Appendix 7

Review of Amendment 32 - Responses to Information Request Dated 15 Nov 2013

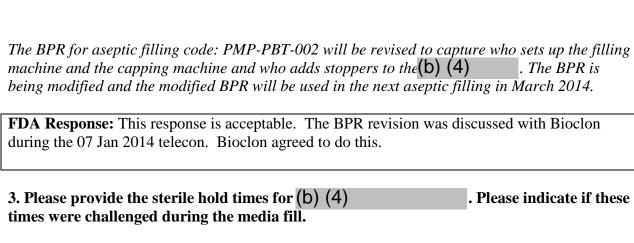
c. There is no indication in the BPR when personnel are monitored so I am unable to determine if there was any personnel monitoring. We would expect personnel monitoring, at a minimum, in the following areas: after set up of the filling line, after adding stoppers to the stopper bowl, after any intervention to the fill line such as removing vials or clearing a jammed line. Please indicate when personnel monitoring took place.

Currently the personnel are only monitored (b) (4)

The plan modification of the BPR for aseptic filling process will (b) (4)
monitoring of personnel in (b) (4)

The BPR is being modified and the modified BPR will be used in the next aseptic filling in March 2014.

FDA Response: Bioclon needs to perform a process map and some type of assessment of their process to determine that personnel are monitored at all appropriate steps since the steps listed above are only the minimum steps we expect personnel to be monitored. This was discussed with Bioclon during the 07 Jan 2014 telecon. Bioclon agreed to do this.
